**AGENDA
CITY PLANNING COMMISSION
CITY OF LIVONIA
Tuesday, August 11, 2026**

1. Petition 2026-06-01-02, submitted by Guggenheim Development, LLC, pursuant to Section 13.15 of the Livonia Zoning Ordinance, as amended, requesting to rezone the property at 32520 Seven Mile Road from C-1 (Local Business) to C-2 (General Business) to allow for an automobile and light truck repair facility (Jiffy Lube), located on the north side of Seven Mile Road between Shadyside and Mayfield Avenues in the southwest ¼ of Section 3.

PLANNING COMMISSION STAFF NOTES

SITE PLAN

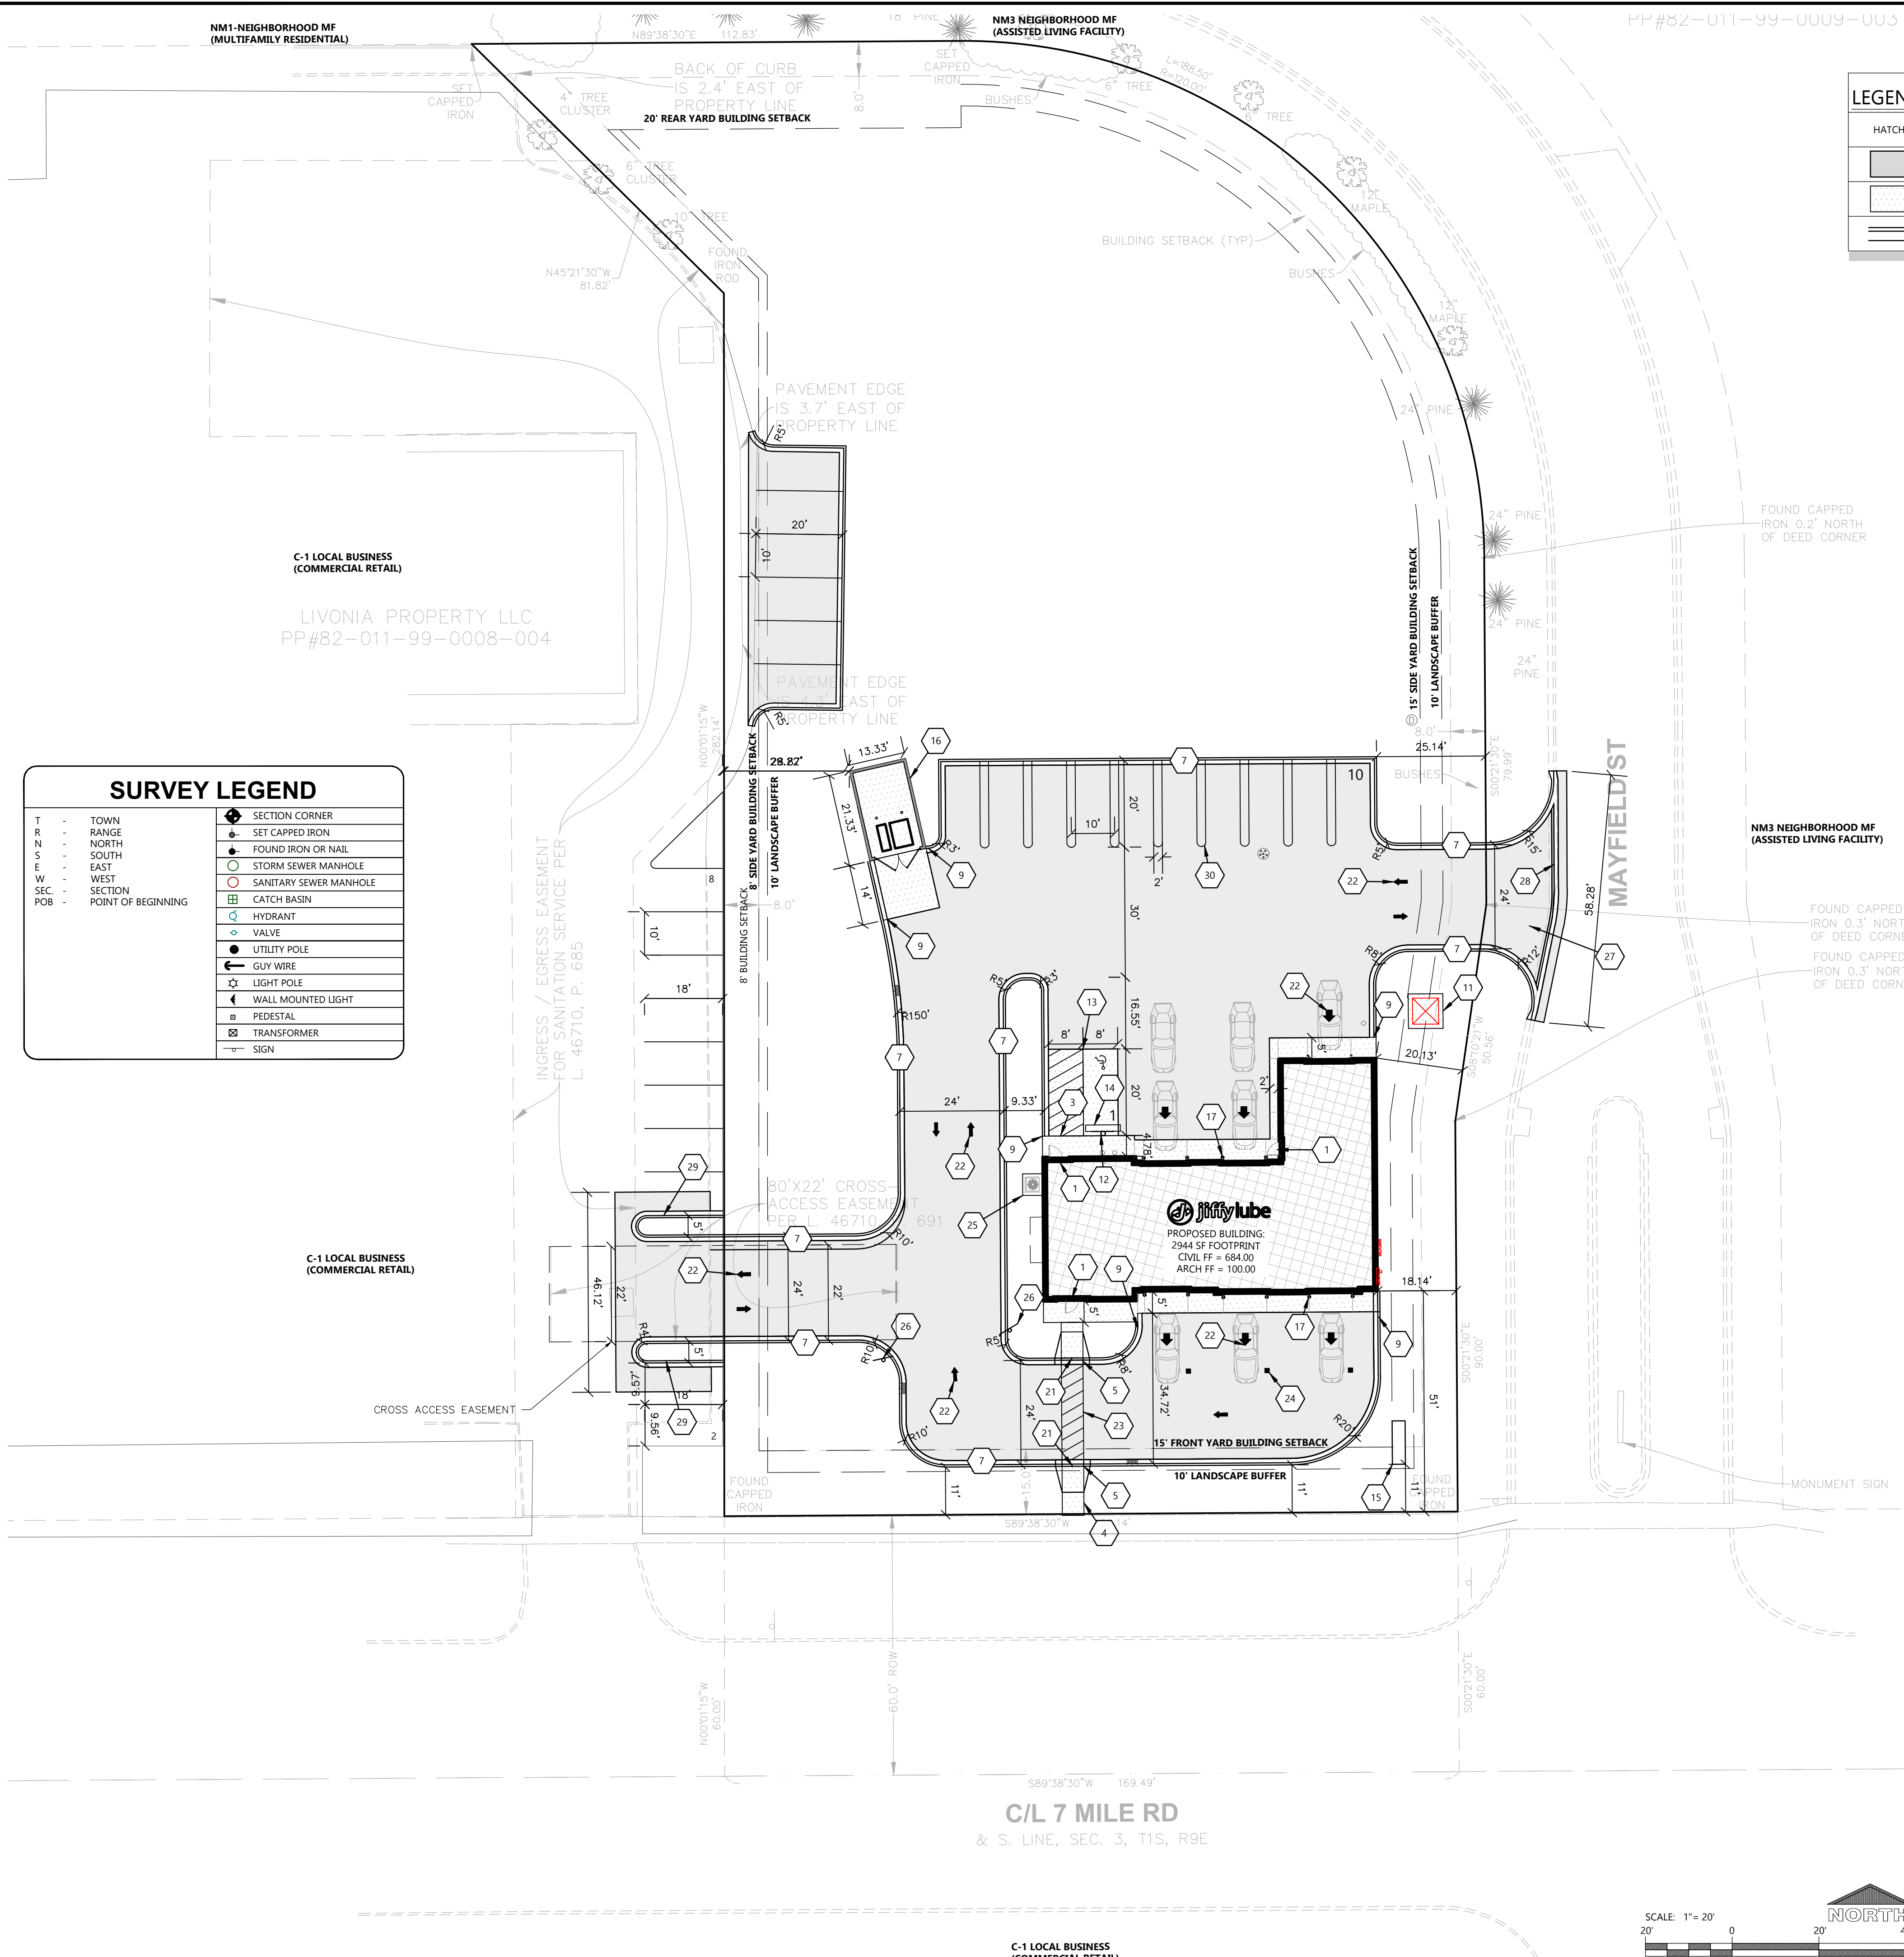
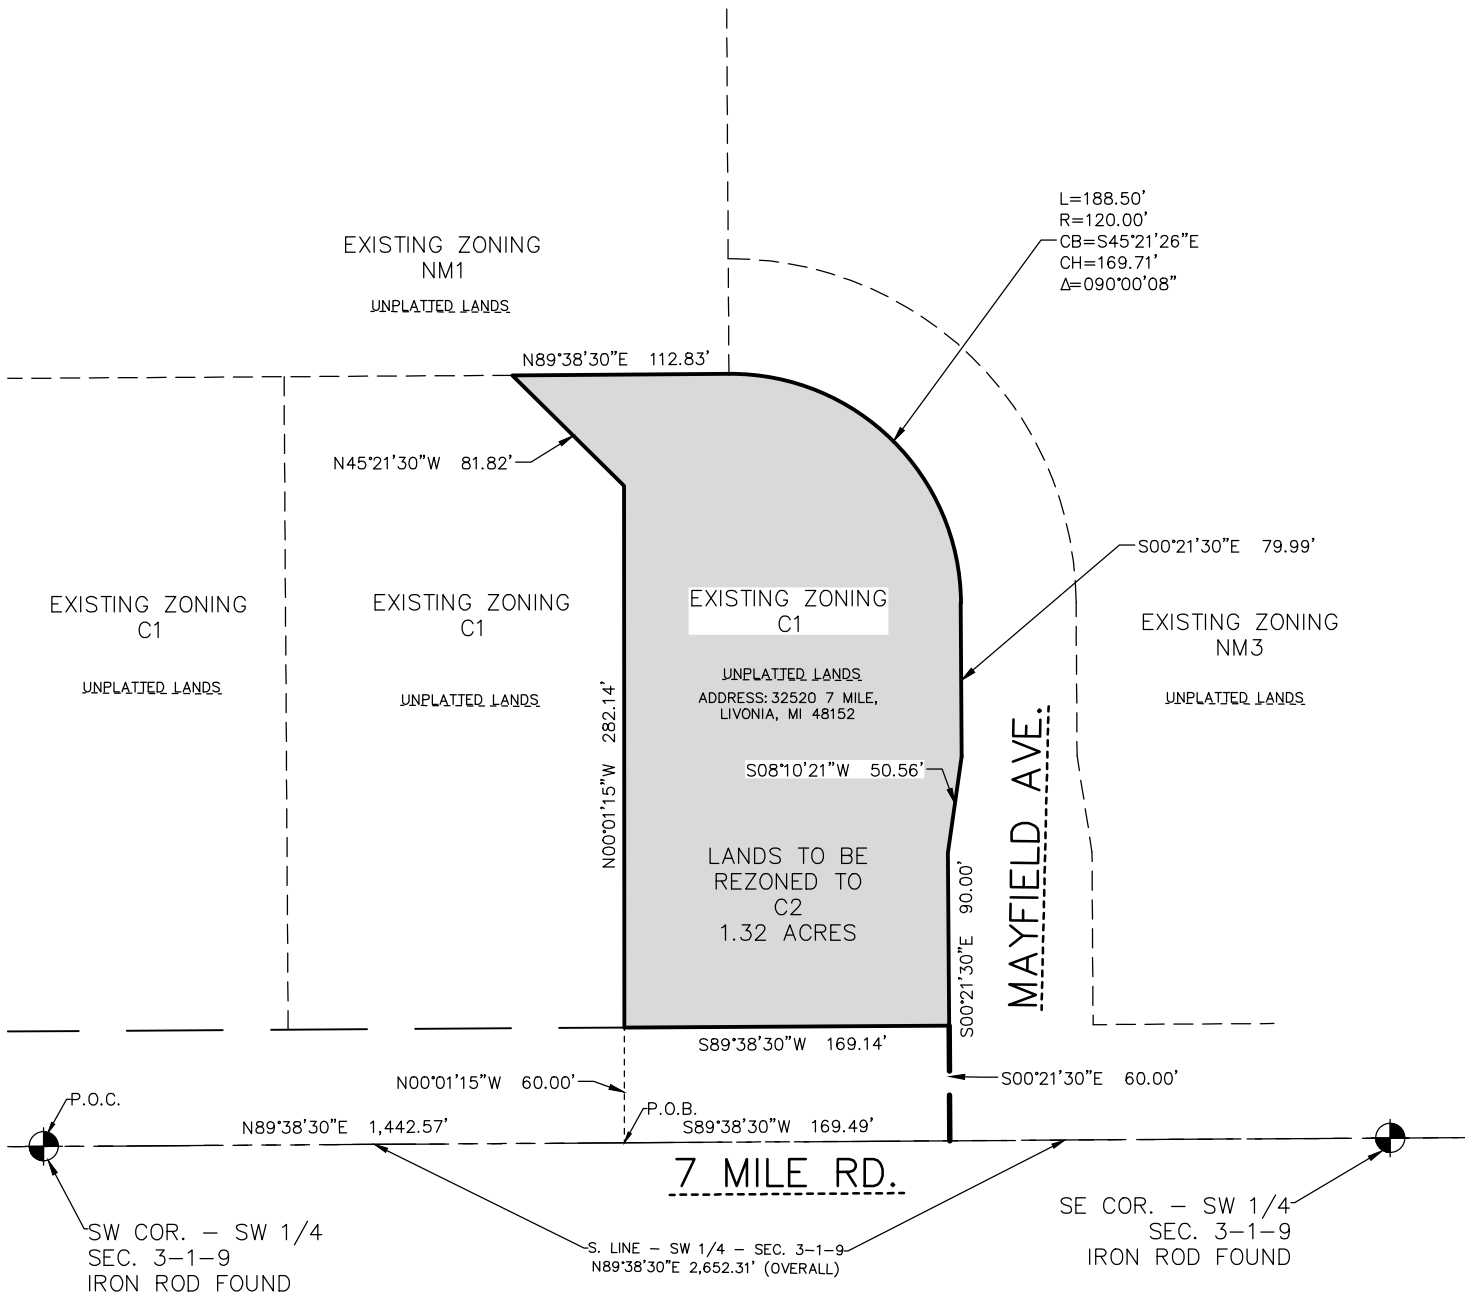
Preliminary site plans, received June 17, 2026, depict a proposed 2,944-square-foot Jiffy Lube building with a front setback of fifteen (15) feet, side setbacks exceeding eight (8) feet, and a rear setback greater than eight (8) feet. Access to the site is provided by two (2) drive approaches, including one (1) connection from the existing parking lot to the west via easement and one (1) approach from Mayfield Avenue to the east.

The plans also indicate the placement of a trash enclosure located to the northwest of the proposed building. A total of sixteen (16) parking spaces are proposed, including one (1) barrier-free space.

All exterior lighting on the property, including illuminated signs, shall be erected and hooded, shielded and recessed to be deflected away from any adjacent or neighboring residential property. The petitioner did not provide a photometric plan.

1. The subject parcel is assigned the address of **#32520 Seven Mile Road**.
2. The existing parcels are currently serviced by public sanitary sewer, water main, and storm sewer. Proposed utility services are not shown on the submitted plan, but we do not believe there will be any adverse effects on the existing systems with the proposed usage.

4. The owner will need to provide copies of the access easement for the proposed cross-traffic parking access for our records.
5. If the project is approved, engineering drawings will need to be submitted to this department and possible Wayne County for review and permitting.
